Submission - Bella Vista Station Precinct Concept Proposal SSD-10344

The following are specific comments in relation to the exhibition material for the Concept Proposal SSD-10344 with reference to the Development Design Guidelines:-

Figure 4 – Extract of Fig 1.2 from Design Guidelines

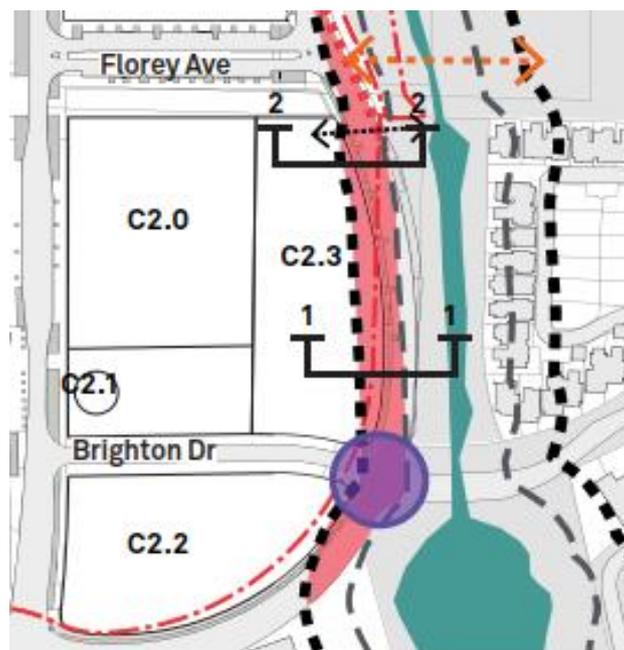
While Figure 1.2, Figure 4 below, from the Design Guidelines depicts a possible Signalised Pedestrian crossing at this location and a new road connection to Celebration Drive and Brighton Drive. Pedestrian priority is considered warranted, however the new location for Brighton Drive as a four-way road intersection is very questionable in terms of meeting engineering design standards for turning vehicles.

In addition Celebration Drive is a constant horizontal curve from the Old Windsor Road end and has several blind traffic spots as you approach Brighton Drive.

The location for a new four-way intersection on Brighton Dr is very questionable from a traffic safety point of view.

Photo 2 - looking from our backyard into the development sites.

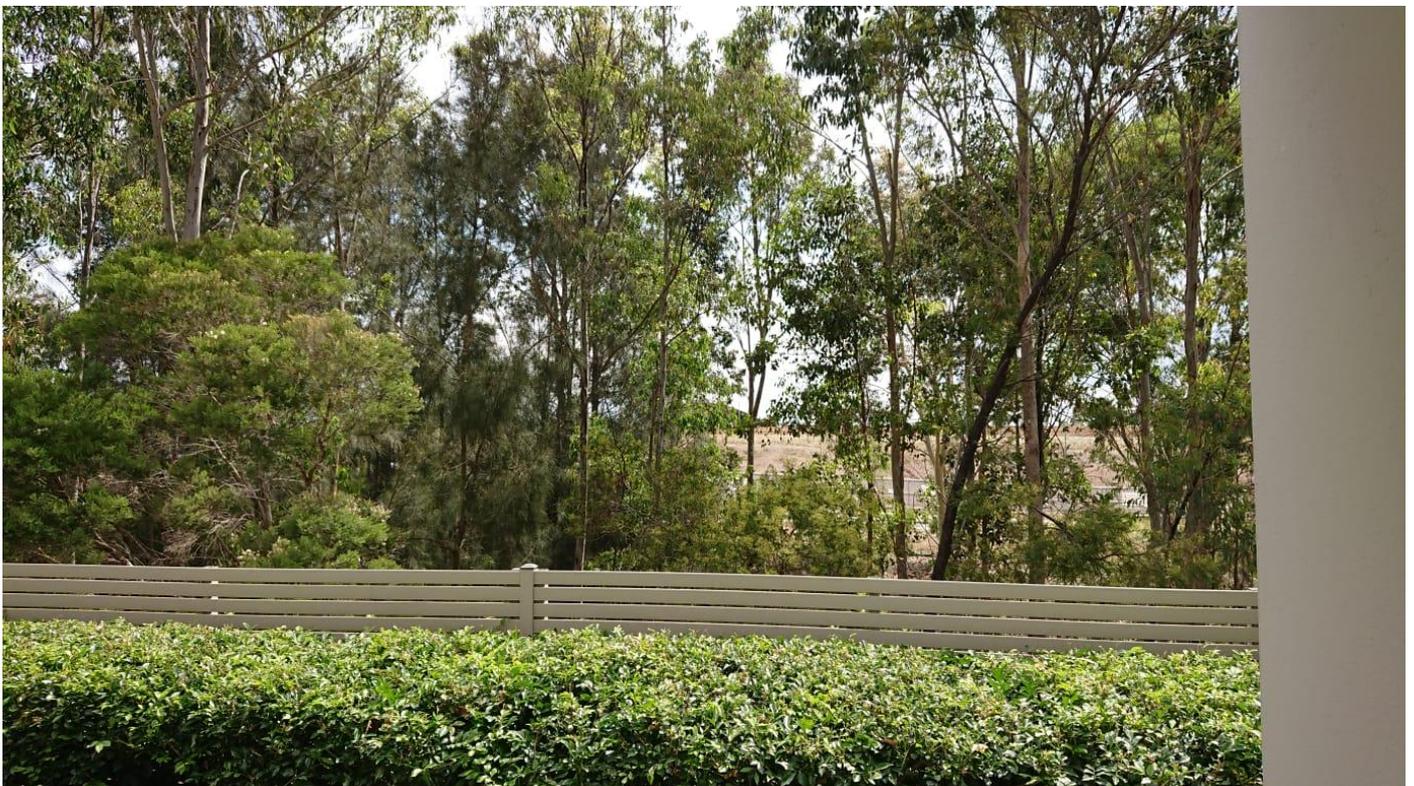
While Elizabeth Macarthur Creek separates the proposed development from our dwelling, this distance is less than 40 metres to Celebration Drive. With the width of Celebration Drive there is very little opportunity to landscape the frontage of any developments proposed for the development site.

Our view from the backyard of our dwellings as shown below in Photo 2 is looking directly onto the development sites proposed with this Concept proposal.

Figure 5 – Extract from Fig 1.4 of the Design Guidelines

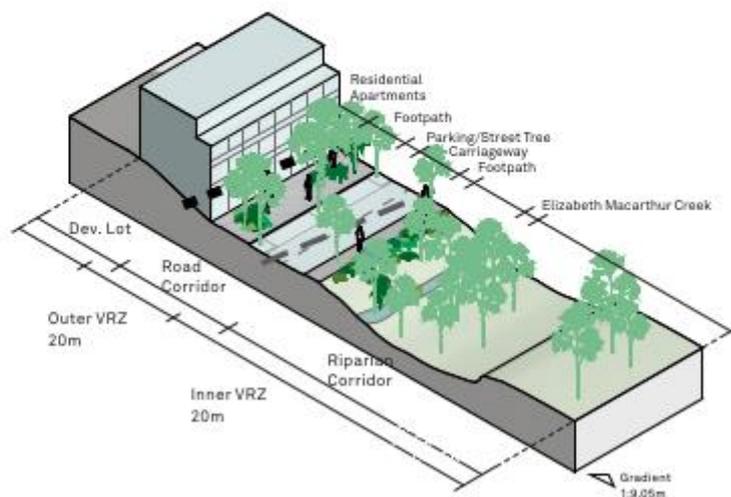
Figure 5 below is an extract from Figure 1.4 of the Design Guidelines showing a treatment of the creek cross section directly across from our property. **This figure shows that there is the intent for a pedestrian path on the creek side of Celebration Drive, which clearly cannot be accommodated within the creek corridor as this would eliminate more opportunity for landscaping along the creek corridor.**

This cross section also demonstrates that the proposed buildings that are fronting Celebration Drive are encroaching any opportunity for landscaping along the property frontages of the development sites. The landscape context of Bella Vista is situated as part of the Norwest Business Park with vast areas for landscaping setbacks for the property frontages.

The Concept proposal for no landscaping setbacks on Celebration Drive is out of context with the surrounding Business Park and Residential areas and is detrimental to the opportunity for any landscaping along the property frontages to aid in screening the future development.

Figure 6 – Extract Figures 2.1 & 2.2 from Design Guidelines

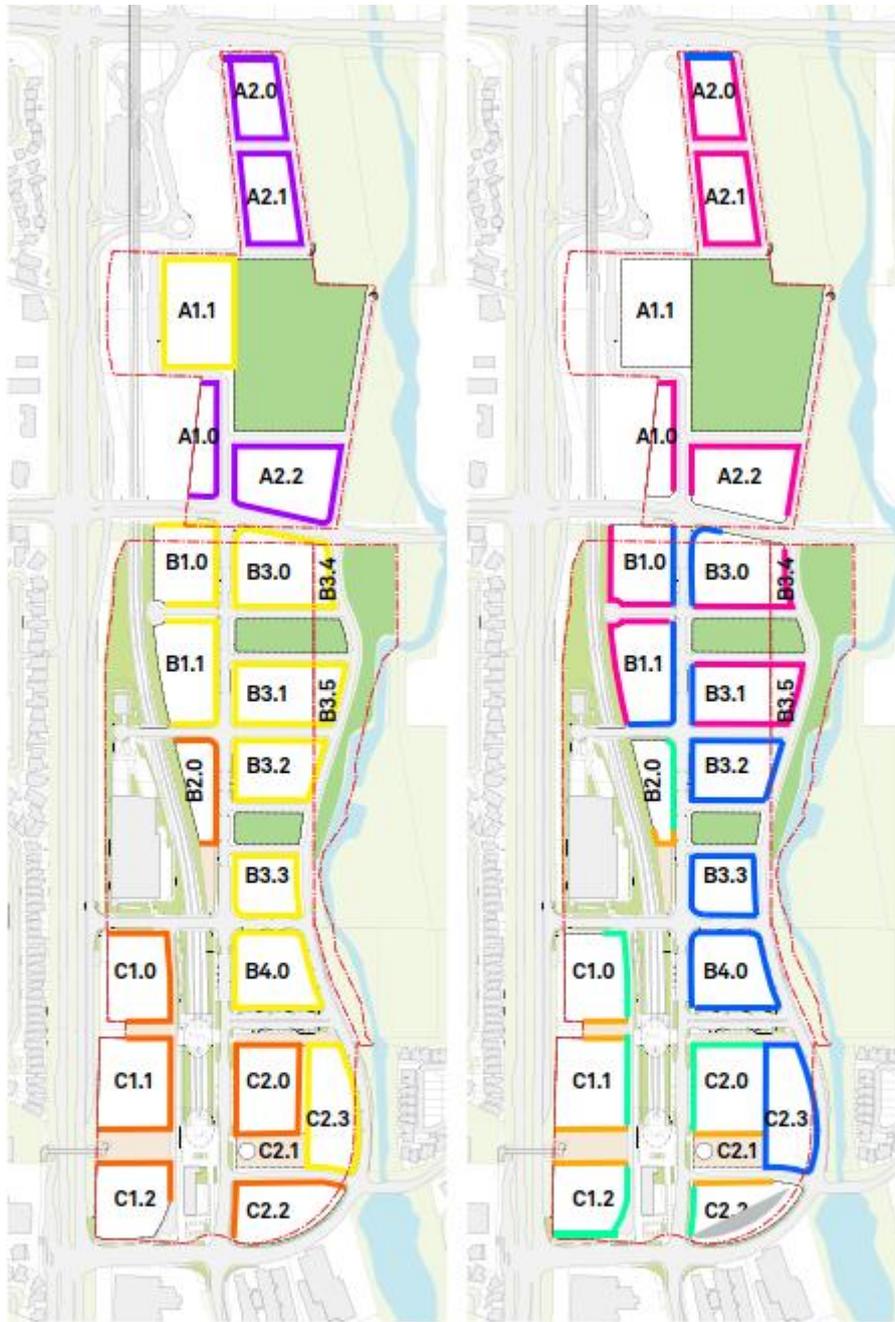
The building setbacks for the blocks that are directly opposite my property are C2.3 as shown in Figure 6 and Figure 7 below.

The setback treatment on the ground floor are shown as 0 – 2 metres, while the levels 4 – 6 storeys is setback only 3 metres (reference to Figure 2.1 & 2.2 from Design Guidelines). **This setback treatment is considered as minimal and does not adequately allow any significant area for landscaping in the front setback.**

This section of Celebration Drive is the closest point to the existing dwellings and our dwelling is one of the closest in the group of dwellings in our complex to the future development site. **The minimal landscape setback is adversely affecting the opportunity for adequate landscape treatment to provide a buffer to the future buildings.**

There is no reason for this setback being as reduced as other areas along Celebration Drive have a greater setback being some 2 – 5 metres on the ground floor and 5 metres on the upper floors. The treatment should be amended to have regard to the closet point to the dwellings and provide more opportunity for landscaping.

It is strongly suggested that the building setback should be increased on Celebration Drive with Block C2.3, which should be setback 2 – 5 metres on the ground floor for landscaping.
